Illinois Department of Transportation

SUBJECT: Mt. Vernon Outland Airport
Mt. Vernon, Illinois
Jefferson County
Illinois Project Number: MVN-5015
SBG Project Number: N/A
Contract No. MV069
Item No. 05A, 3/08/2024 Letting
Addendum B

NOTICE TO PROSPECTIVE BIDDERS

**PROPOSED PARKING LOT
TYPICAL SECTION**

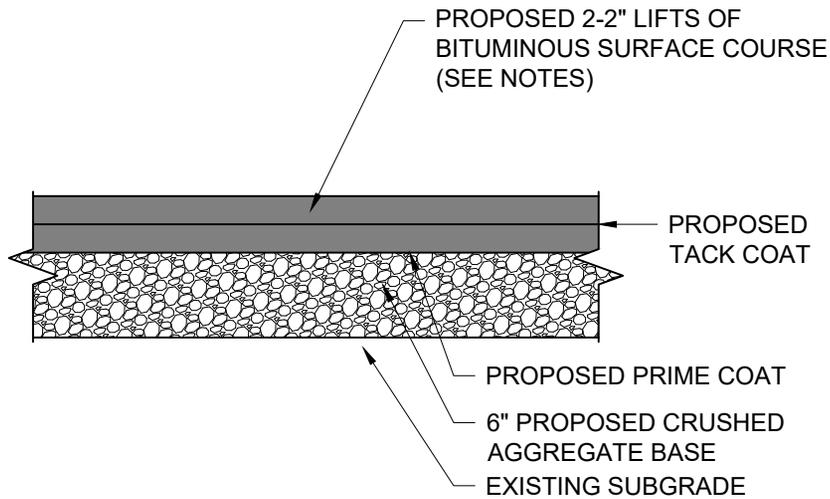
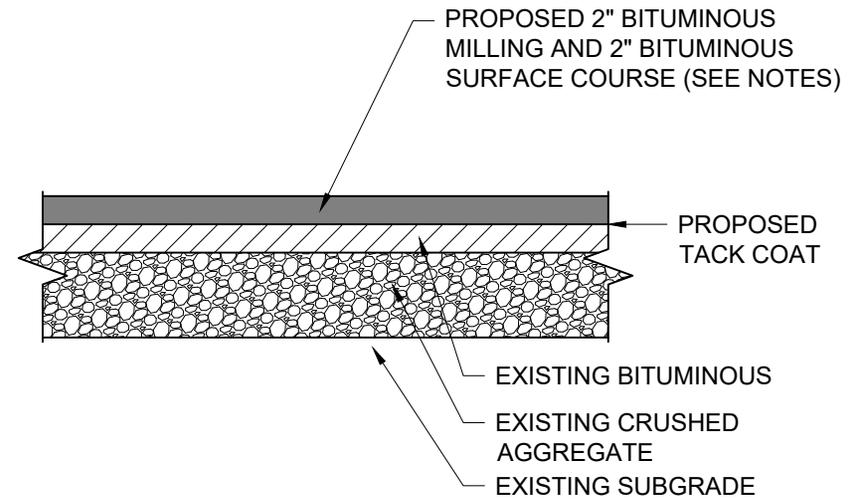
On Plan Sheet No. 14, Typical Sections, the notes for "Proposed Parking Lot Typical Section" and "Parking Lot – Typical Section" are revised per the attached exhibit.

1. SECTION 401 (SUPERPAVE) OF THE "STANDARD SPECIFICATIONS FOR CONSTRUCTION OF AIRPORTS," ADOPTED APRIL 1, 2012 SHALL GOVERN ALL MATERIAL REQUIREMENTS FOR THIS ITEM.
2. THE "AC TYPE" SHALL BE "PG 64-22".

1. SECTION 401 (SUPERPAVE) OF THE "STANDARD SPECIFICATIONS FOR CONSTRUCTION OF AIRPORTS," ADOPTED APRIL 1, 2012 SHALL GOVERN ALL MATERIAL REQUIREMENTS FOR THIS ITEM.
2. THE "AC TYPE" SHALL BE "PG 64-22".
